NSW Independent  
Planning  
Commission

Pitt Street South  
OSD

INTERNAL AMENITY  
SUBMISSION

18 March 2021  
Final

/39 GRC elements  
/900mm wide  
/400mm deep  
/50mm gap to facade

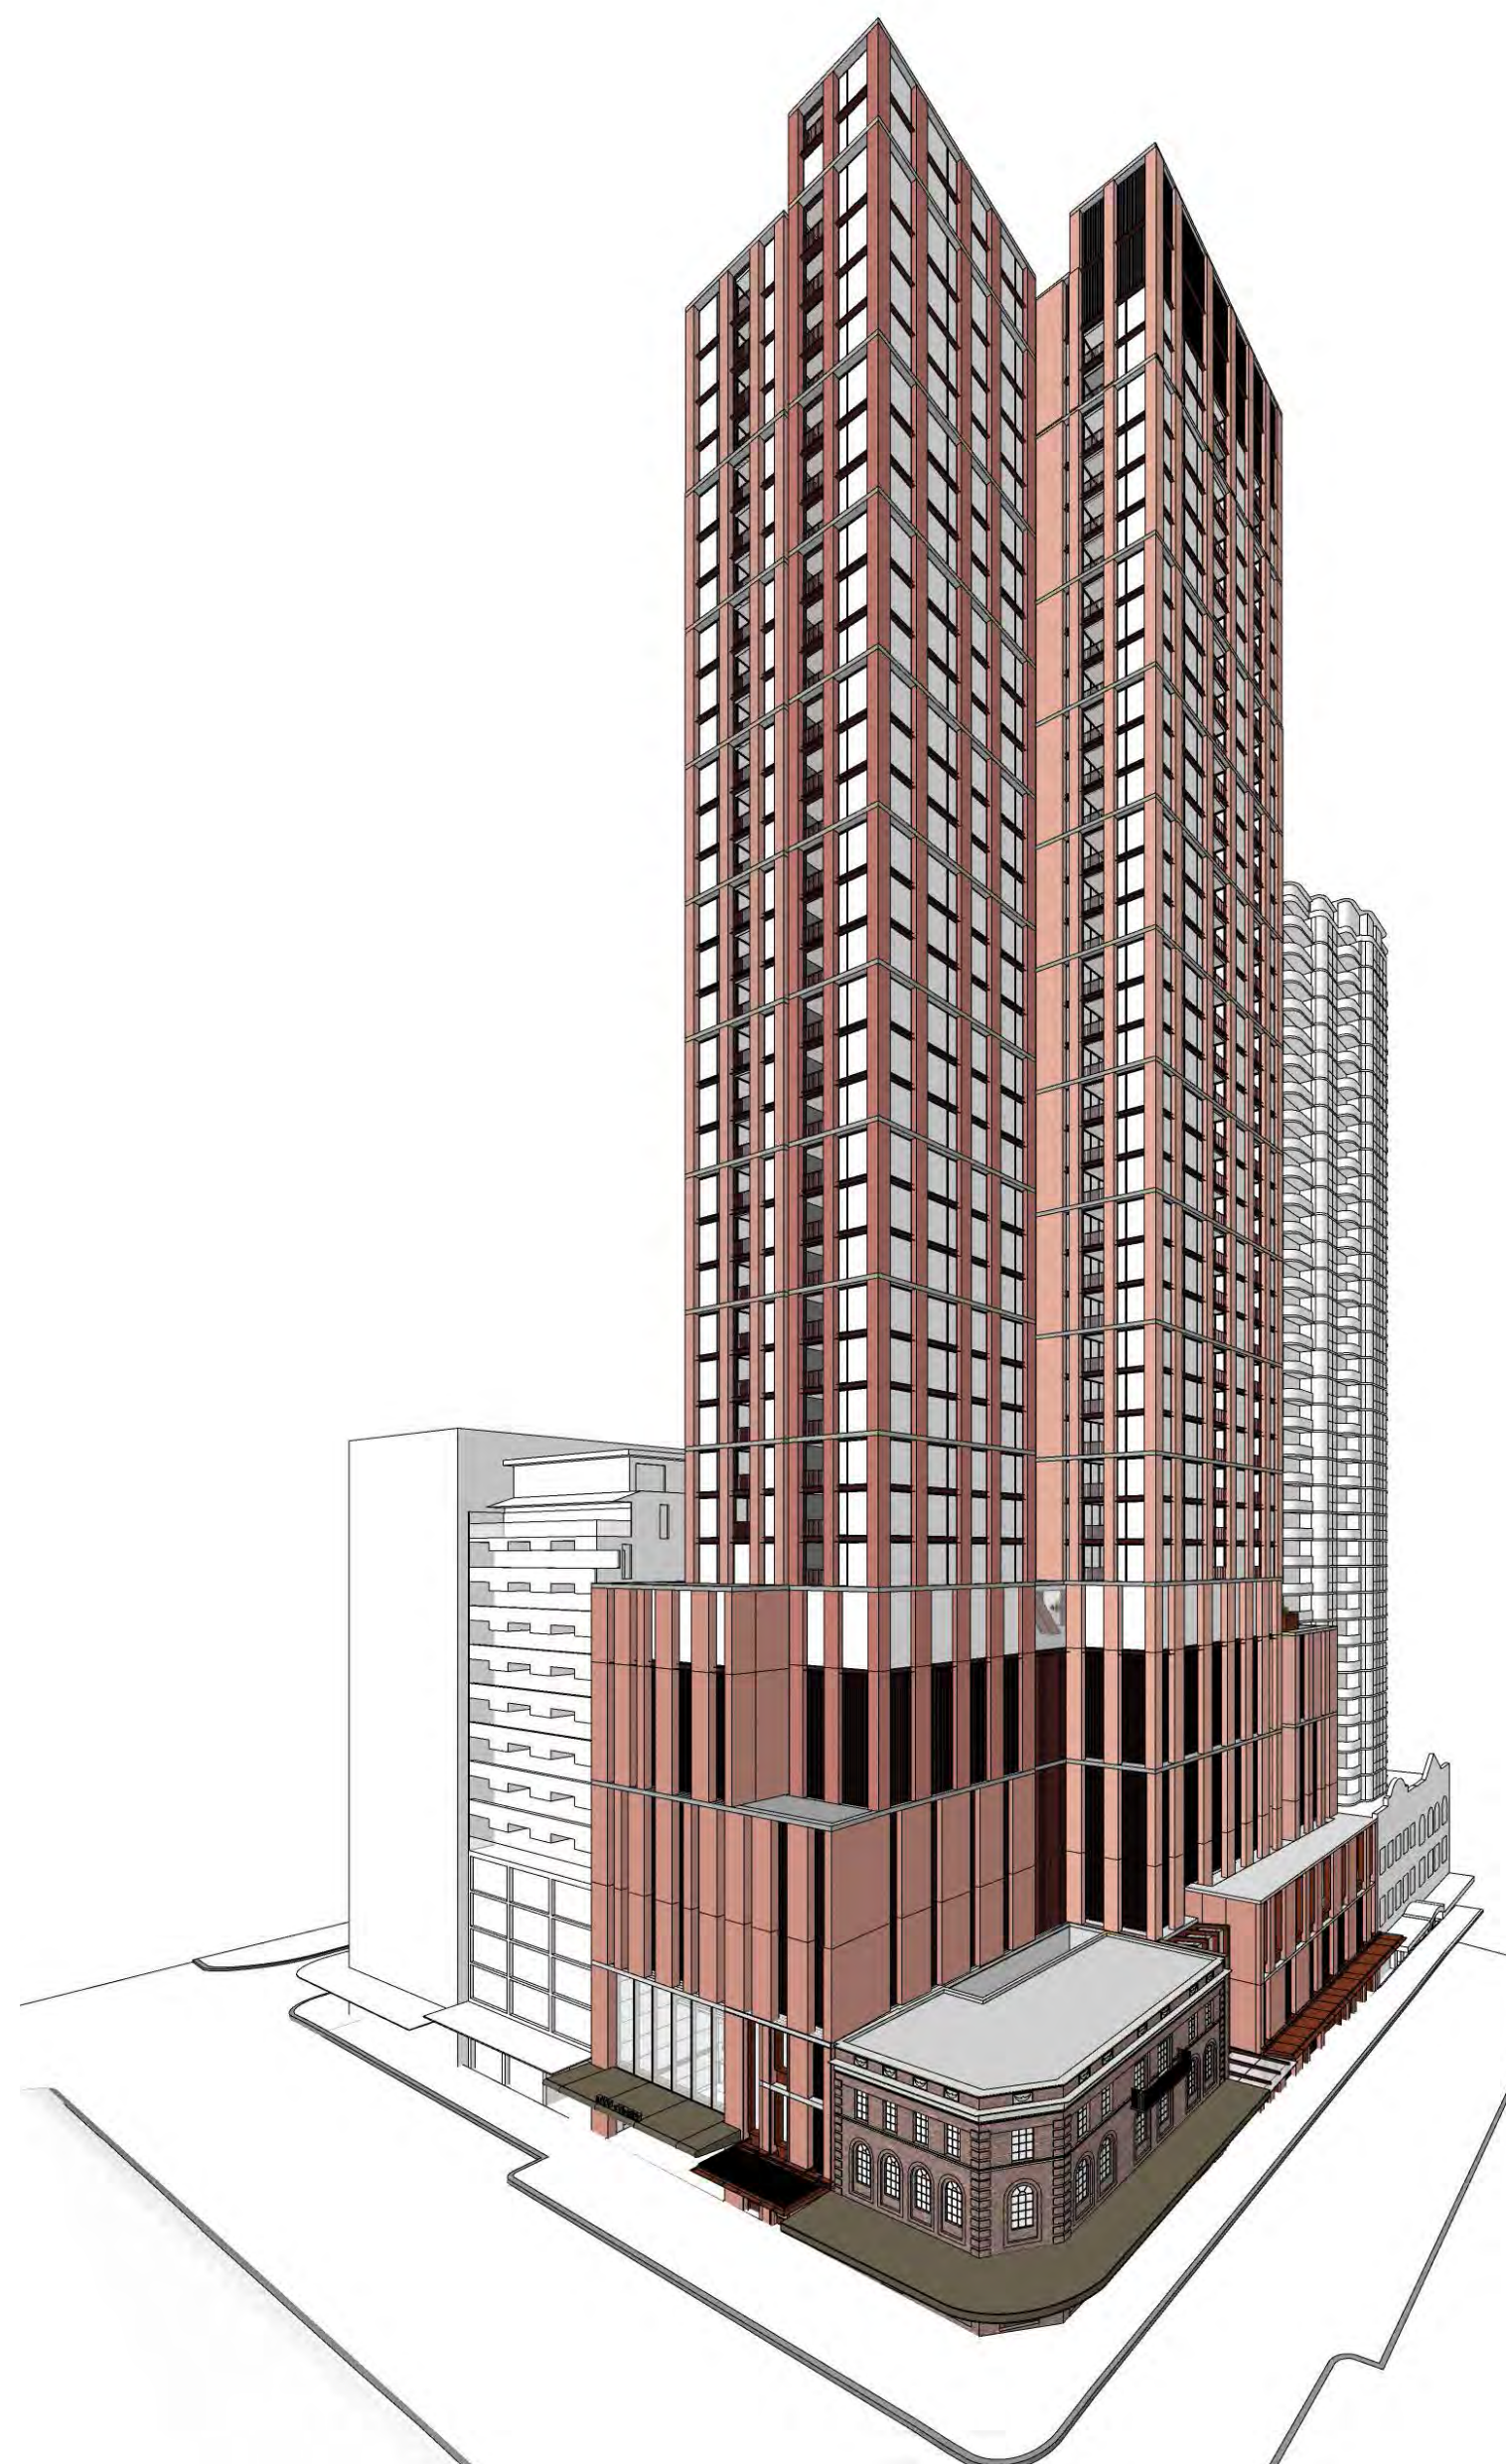
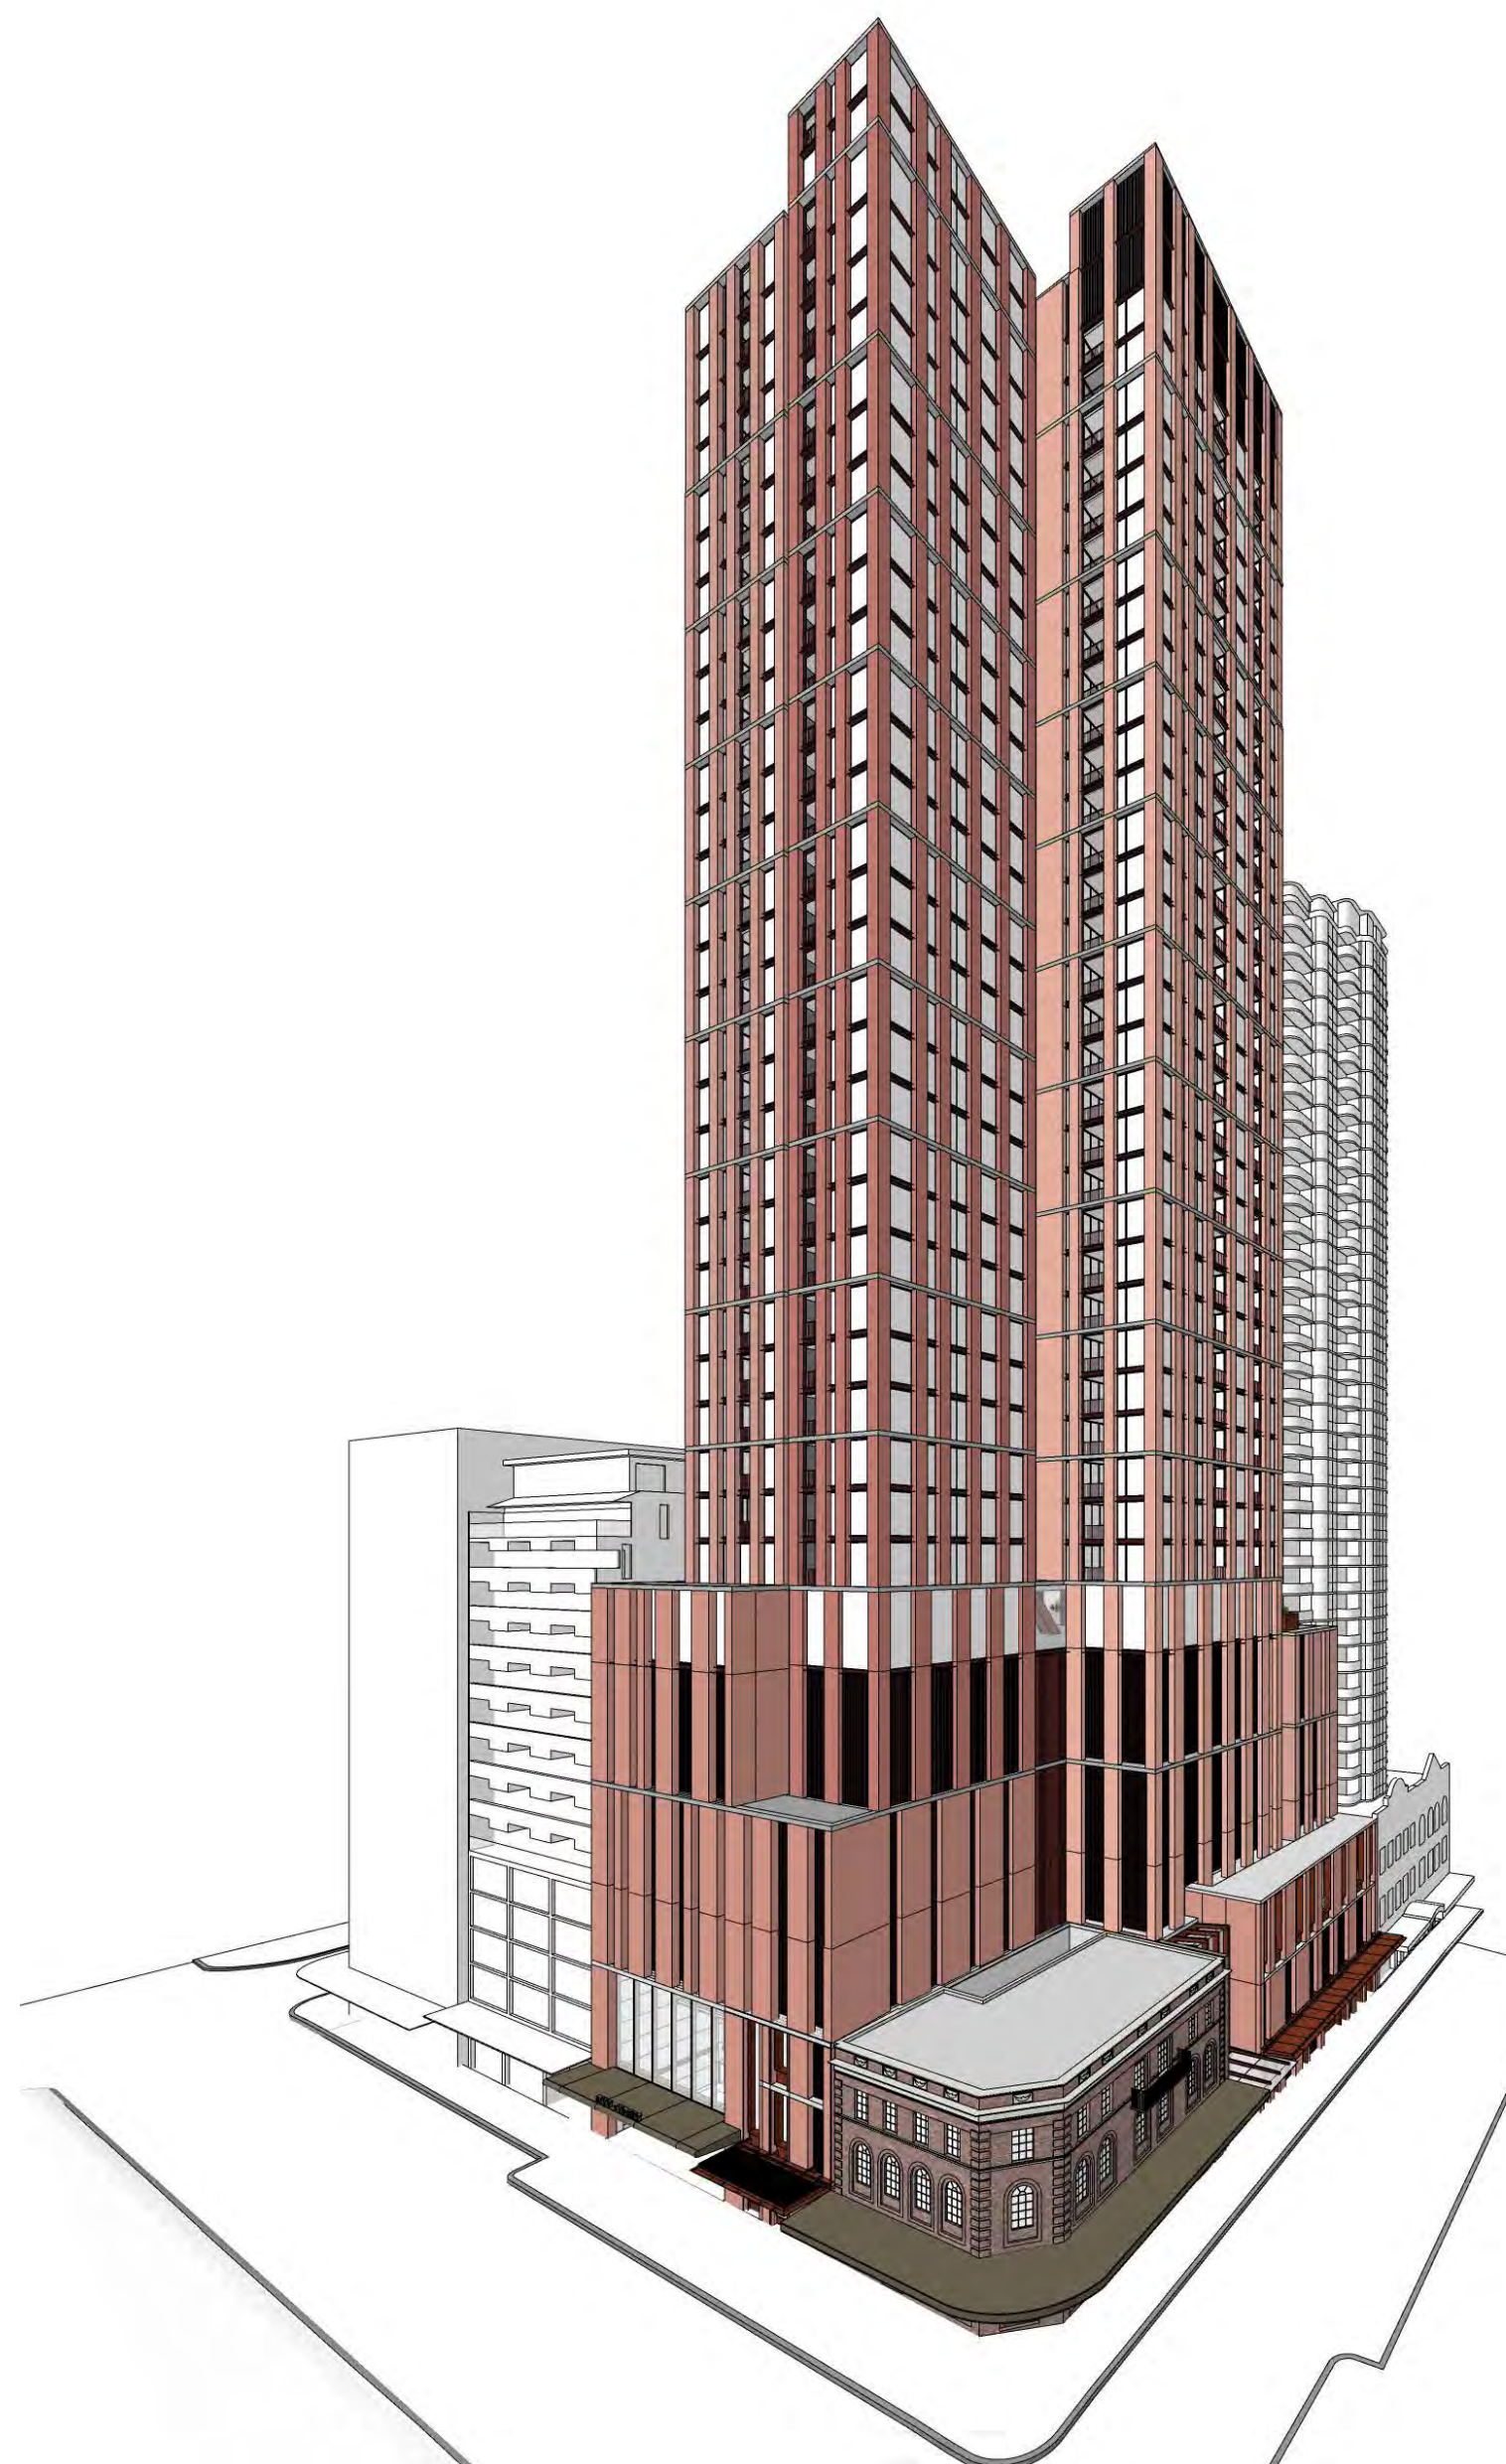
The reduction in columns made to the OSD South façade, presented in DRP 12 and 13, has a significant impact on the overall appearance and visual quality of the building and is not supported by the Panel. Whilst the Panel supports the greater level of consideration that has been given to the rationalisation of window/solid to internal planning, it recommends reviewing the original density and syncopated rhythm of the SSDA proposal, to recapture this design quality.

*One vertical added to living rooms on north east and west facades -  
logic: each face of a volume has one ‘point of compression’*

/39 GRC elements  
/900mm wide  
/400mm deep  
/50mm gap to facade

/44 GRC elements  
/900mm wide  
/400mm deep  
/50mm gap to facade

/39 GRC elements  
/900mm wide  
/400mm deep  
/50mm gap to facade

/44 GRC elements  
/900mm wide  
/400mm deep  
/50mm gap to facade
